Service Bulletin

PRELIMINARY INFORMATION

Subject: Popping Noise From Front of Vehicle When Traveling Over Bumps

Models: 2013-2015 Cadillac ATS
2014-2015 Cadillac CTS (VIN A)

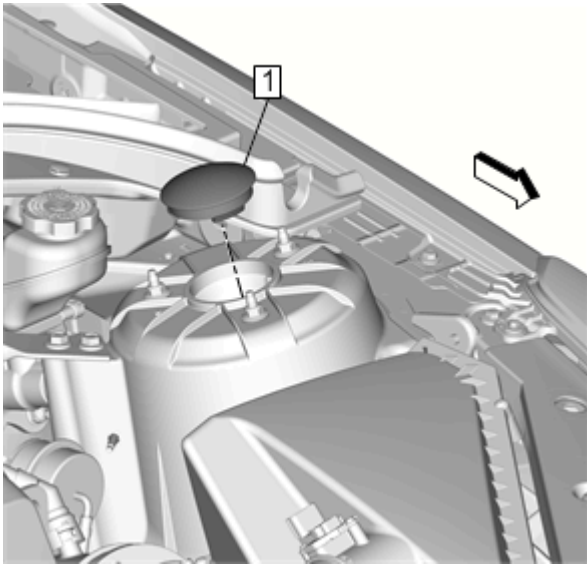
Some customers may comment on a popping noise when traveling over bumps.

This may be caused by the front strut mount being torn due to high underbody/underhood temps in addition to traveling over speed bumps.

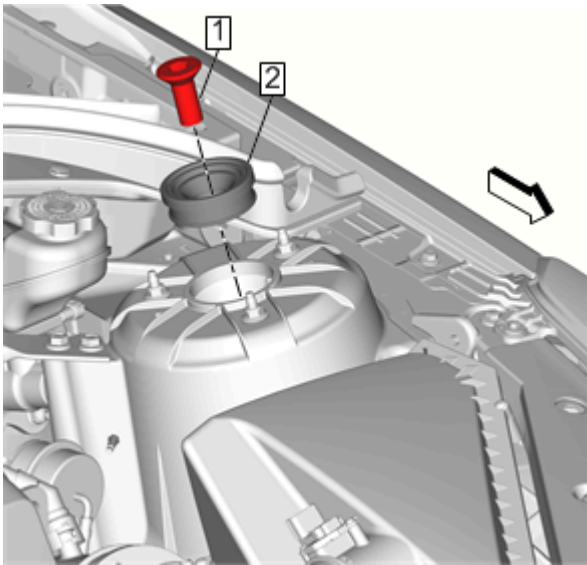
1. Remove and discard both the front suspension strut upper mounting caps (1).
2. Inspect both front strut top mounts from inside cavity for tears.
If damage has occurred to the front strut mount, replace the both strut mounts. Refer to Strut, Strut Component, or Spring Replacement in SI.

Note: The following parts (1) and (2) will not be present in vehicles that exhibit this condition. The following parts are the permanent corrective action to prevent the front strut mount from tearing.

3. In addition to replacing the strut mounts, install both the front suspension strut mount upper rebound cups (2).
4. Install both the front suspension strut mount rebound stops (1) and tighten to 25 Y (18 lb ft).

Important: Tighten with the vehicle resting on the ground and ensure rebound stop is fully seated against the strut rod nut.
